Access Compliance Report

Public Rights-of-Way

(Curb Ramps)

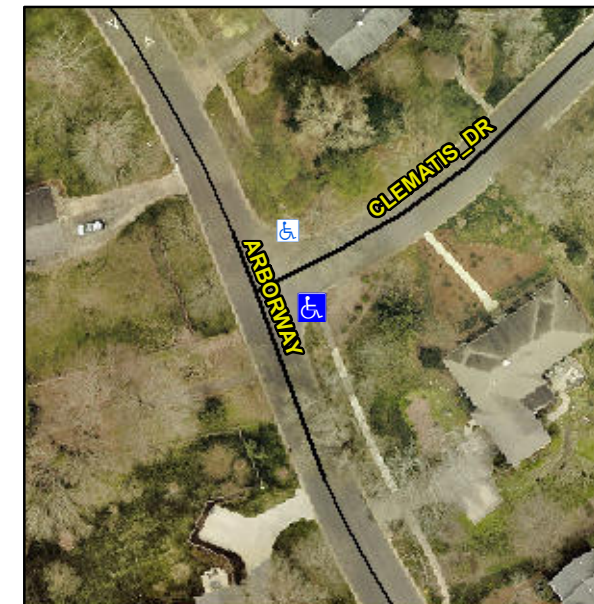
Intersection ID: 20383	Main Street: CLEMATIS_DR	Cross Street: ARBOR_WAY	Location: SE
ADA ID: BDE1E144E924	Ramp Type: Perp	Initial Pass/Fail: Fail	Overall Compliance: No
Severity Score: 33.75			
Codes/Mitigation Info/Possible Solution		Field Measurements/Component Compliance

Not Found, R304.5.1, R304.5.3

Compliance	Description	Data	Compliance	Description	Data
N/A	Ramp Length (in)	60.0	Yes	Ramp Slope (%)	3.5
No	Ramp Width (in)	45.0	No	Ramp XSlope (%)	8.3
N/A	Flare Type LT	N/A	N/A	Flare Type RT	N/A
N/A	Flare Slope LT (%)	N/A	N/A	Flare Slope RT (%)	N/A
N/A	Flare Traversable LT?	N/A	N/A	Flare Traversable RT?	N/A
N/A	Landing Length (in)	N/A	N/A	DWS Provided?	N/A
N/A	Landing Width (in)	N/A	N/A	DWS Contrast?	N/A
N/A	Landing Slope (%)	N/A	N/A	DWS Length (in)	N/A
N/A	Landing X Slope (%)	N/A	N/A	DWS Full Width?	N/A
N/A	Landing Curb? (Y/N)	N/A	N/A	DWS Offset (in)	N/A
N/A	Shared Landing?	N/A			
N/A	Gutter Ponding?	N/A	N/A	Gutter Slope (%)	N/A
N/A	Gutter Lip Ht (in)	N/A	N/A	Gutter X Slope (%)	N/A
N/A	Painted X Walk1?	No	N/A	Painted X Walk2?	N/A
	X Walk 1 Direction	To NW		X Walk 2 Direction	N/A
N/A	X Walk 1 Width (in)	N/A	N/A	X Walk 2 Width (in)	N/A
	X Walk 1 Slope (%)	5.6		X Walk 2 Slope (%)	N/A
	X Walk 1 X Slope (%)	3.5		X Walk 2 X Slope (%)	N/A

Remove & Replace Entire Ramp.
